Wisconsin Department of Transportation

Proposal #10: 1060-34-84
Zoo IC, Center Street Bridge
Over USH 45
USH 45
Milwaukee County

1060-35-85
Zoo IC, Center Street Sidewalk
114th Street to 117th Street
Off System
Milwaukee County

This is Addendum No. 01, which provides for the following:

Addendum No. 01
 ID 1060-34-84 &
 ID 1060-35-85
 Revised Sheet 39
 November 30, 2015

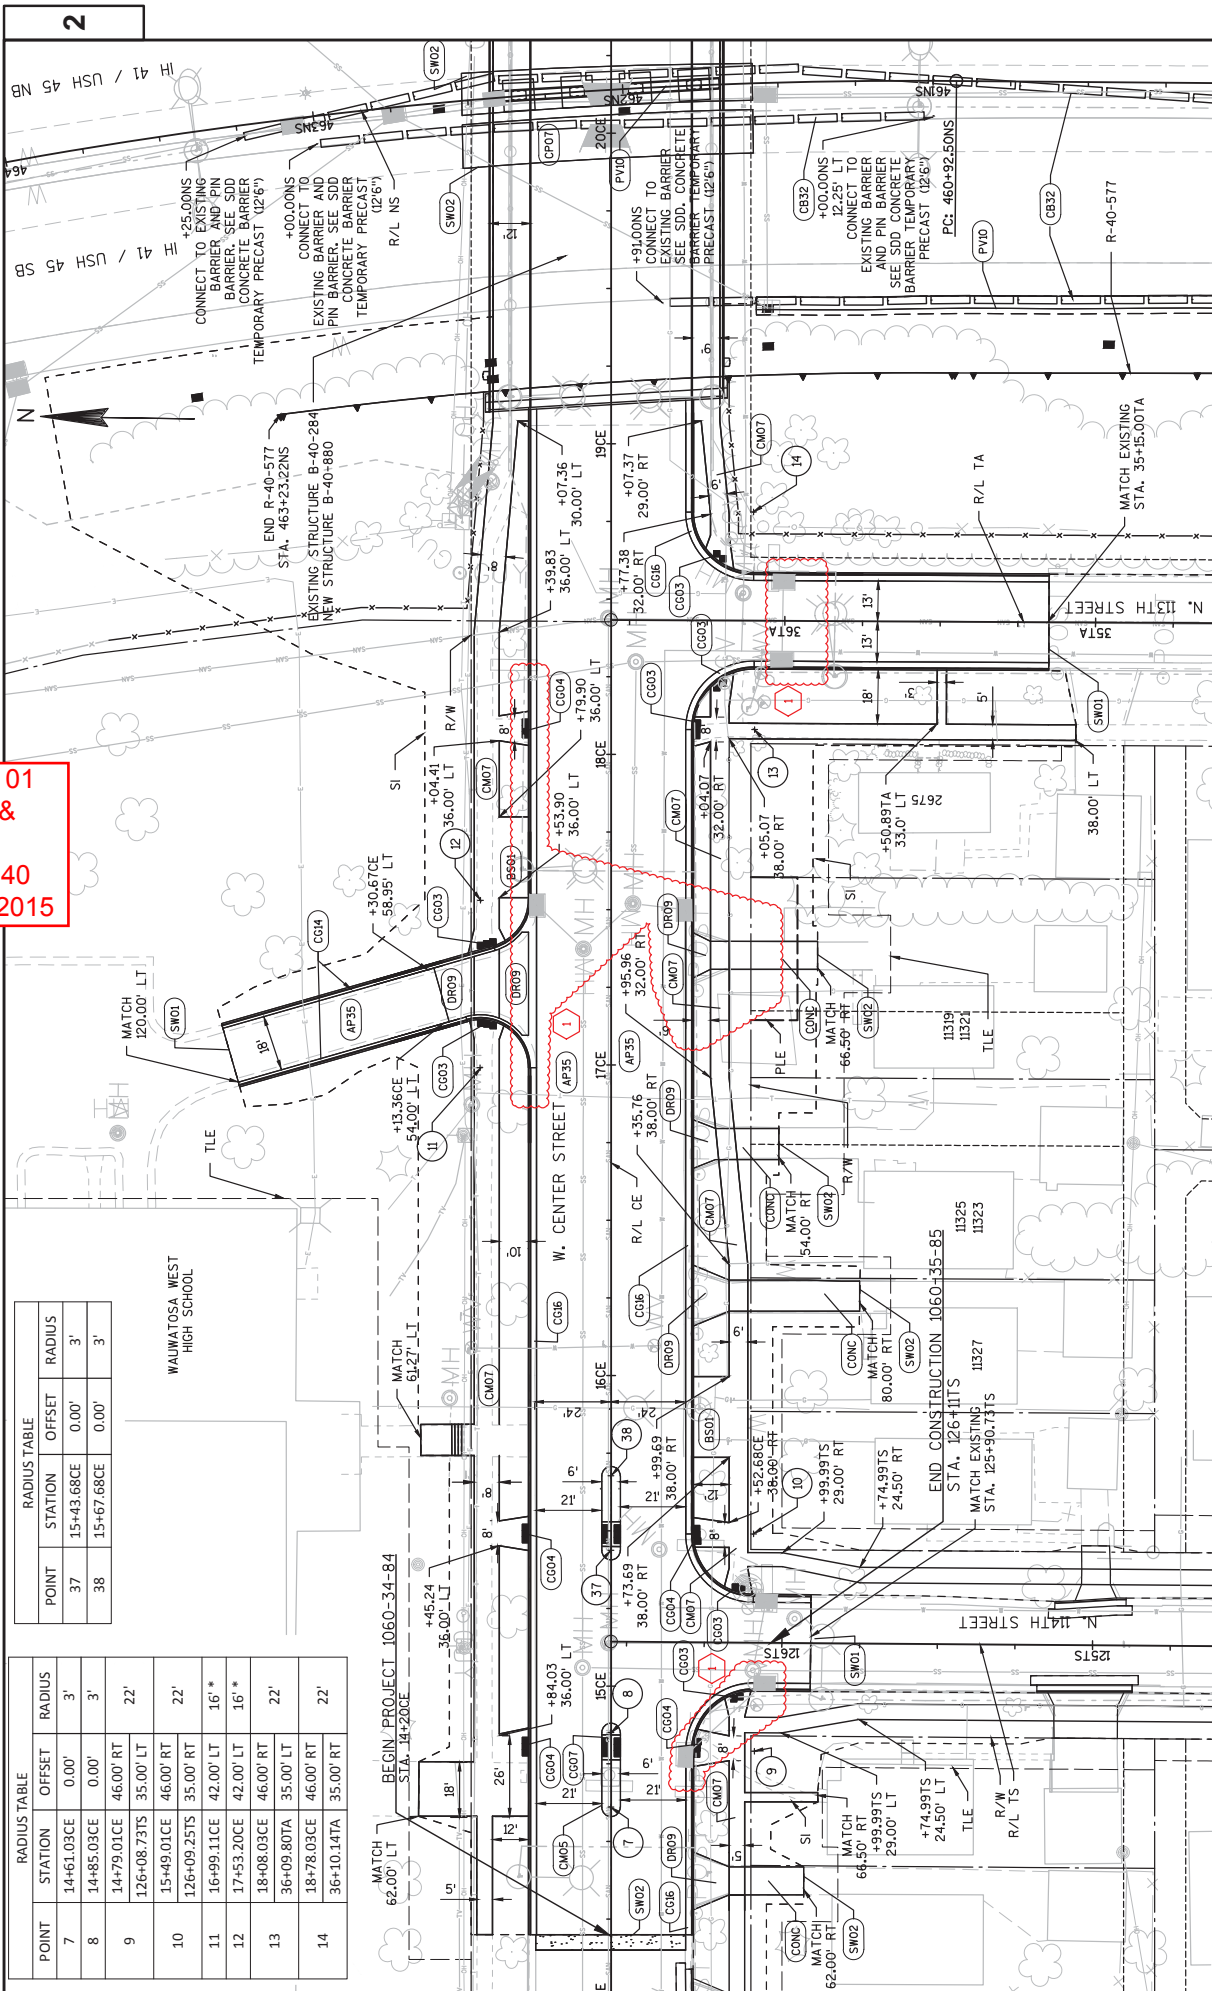
| Revised Plan Sheets | |
|---------------------|---|
| 39 | Plan Details – Removed sections of proposed storm sewer due to Wauwatosa storm sewer project |

Addendum No. 01
 ID 1060-34-84 &
 ID 1060-35-85
 Revised Sheet 40
 November 30, 2015

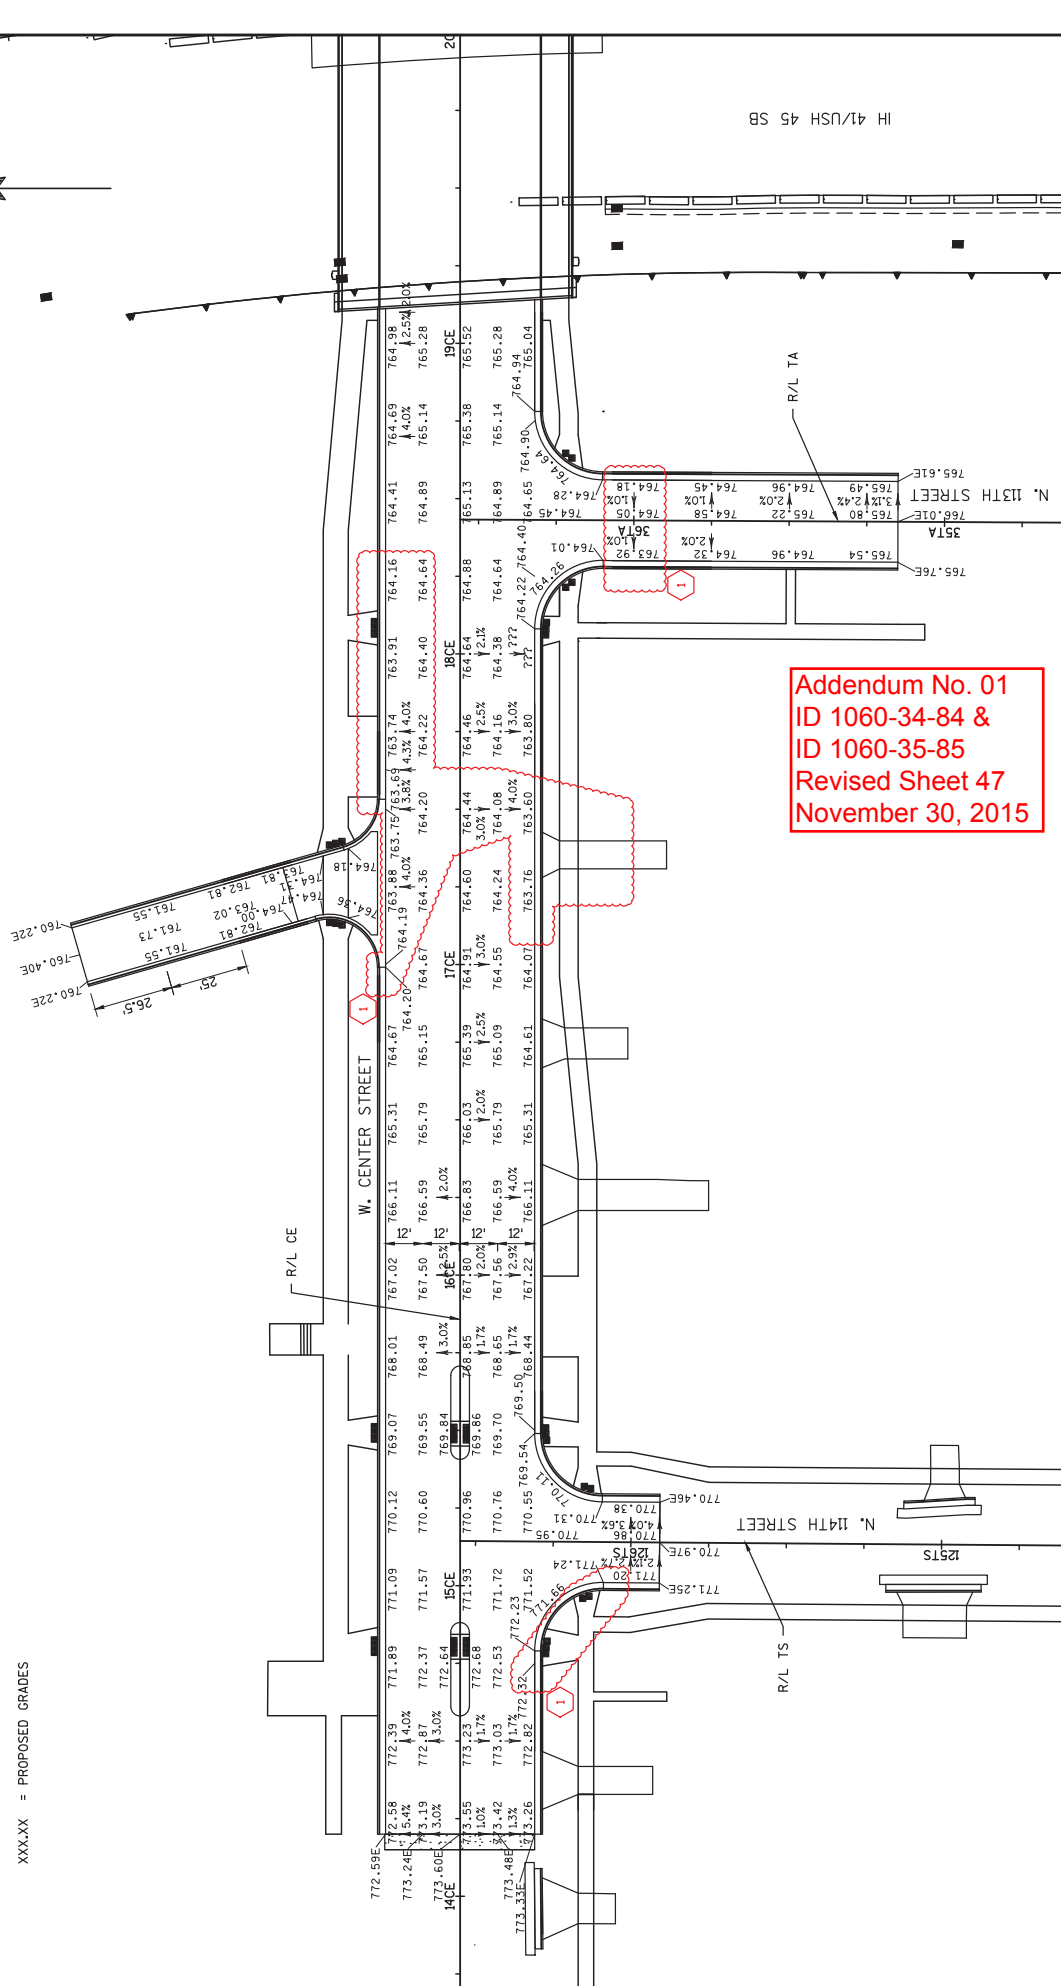
| Revised Plan Sheets | |
|---------------------|---|
| 40 | Plan Details – Removed sections of proposed storm sewer due to Wauwatosa storm sewer project |

Addendum No. 01
 ID 1060-34-84 &
 ID 1060-35-85
 Revised Sheet 47
 November 30, 2015

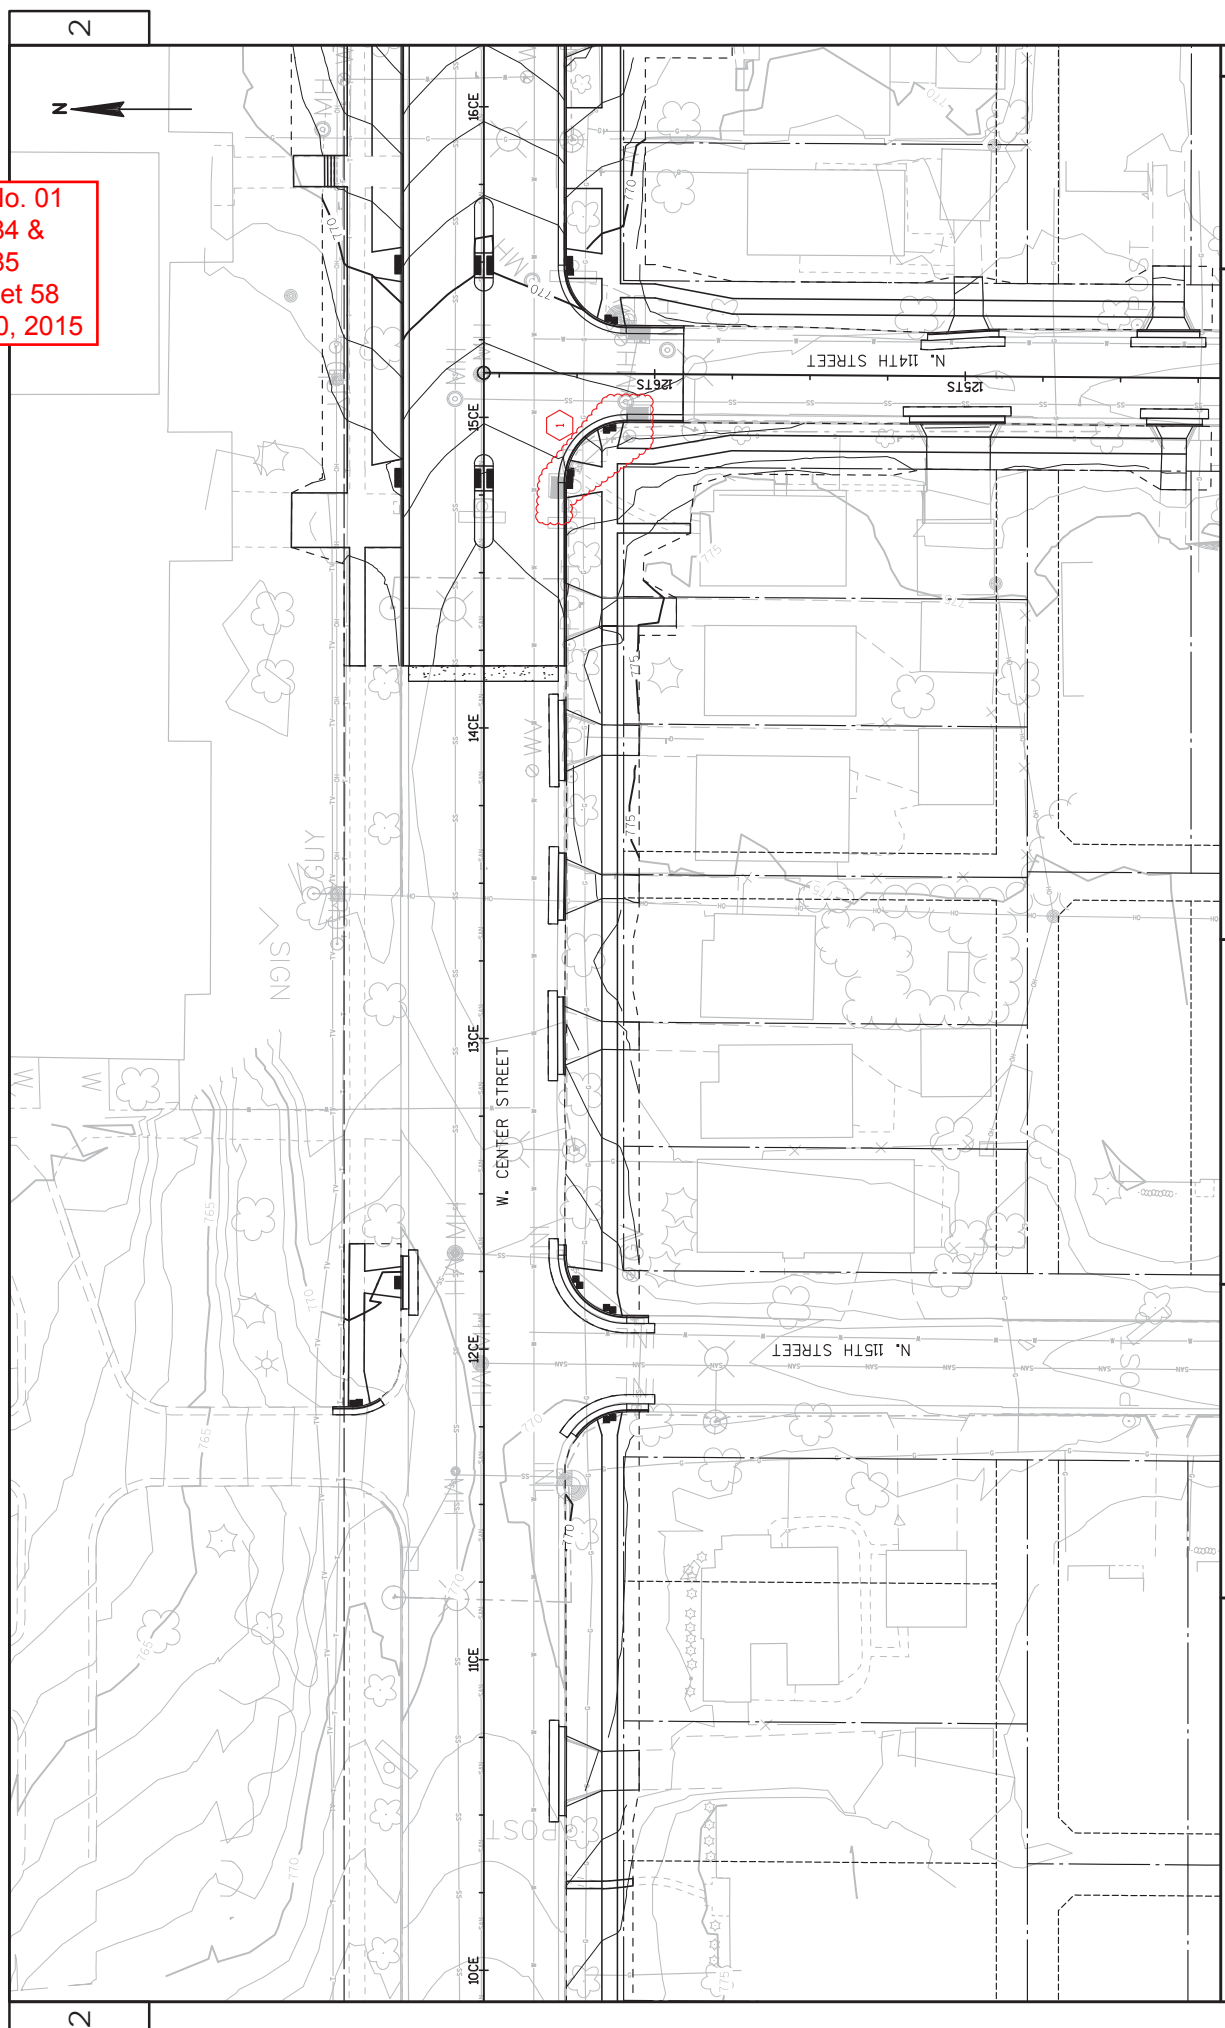
| Revised Plan Sheets | |
|---------------------|---|
| 47 | Grades – Removed sections of proposed storm sewer due to Wauwatosa storm sewer project |

Addendum No. 01
ID 1060-34-84 &
ID 1060-35-85
Revised Sheet 58
November 30, 2015

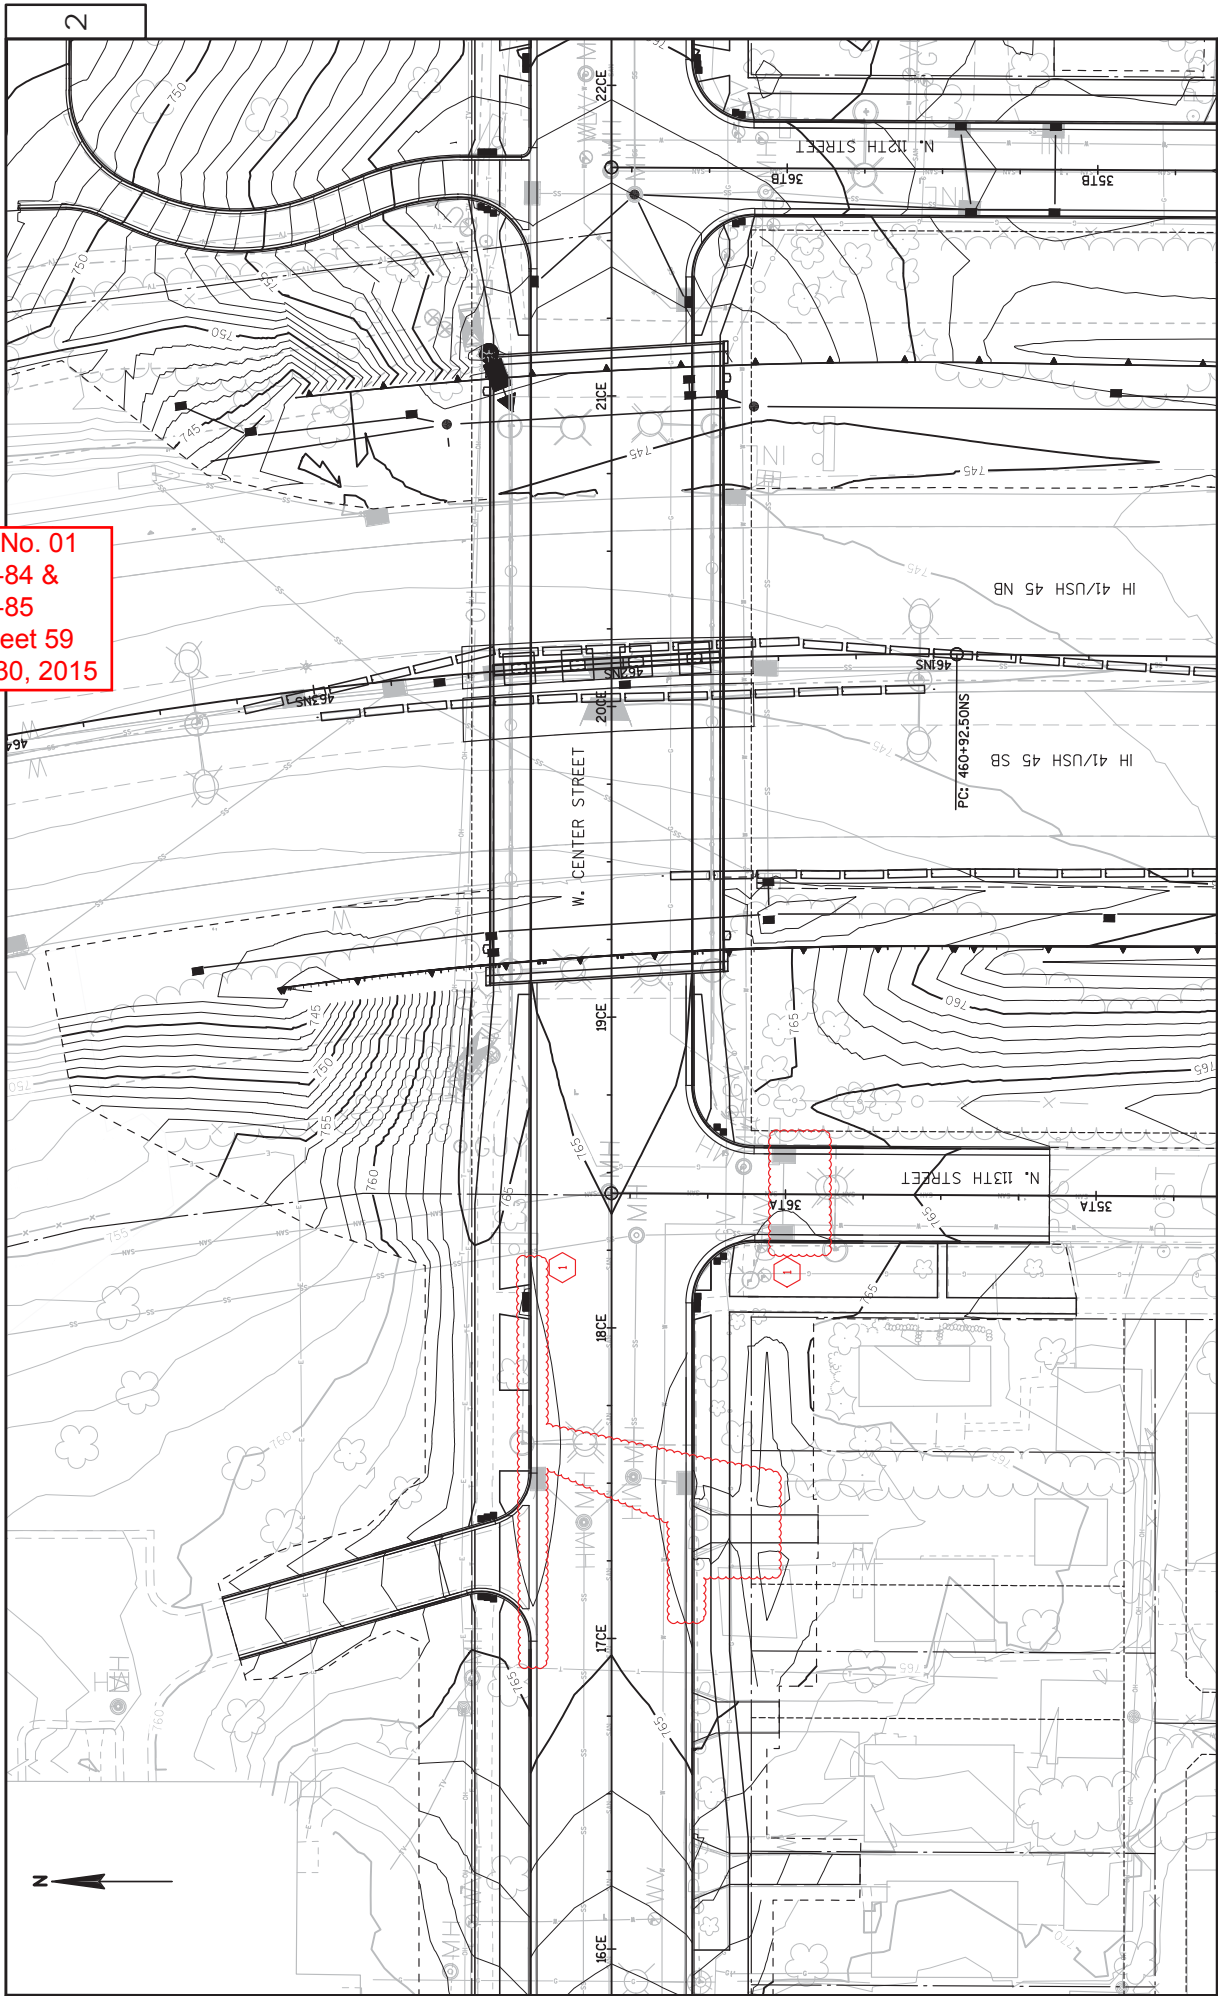
| Revised Plan Sheets | |
|---------------------|---|
| 58 | Contour Map – Removed sections of proposed storm sewer due to Wauwatosa storm sewer project |
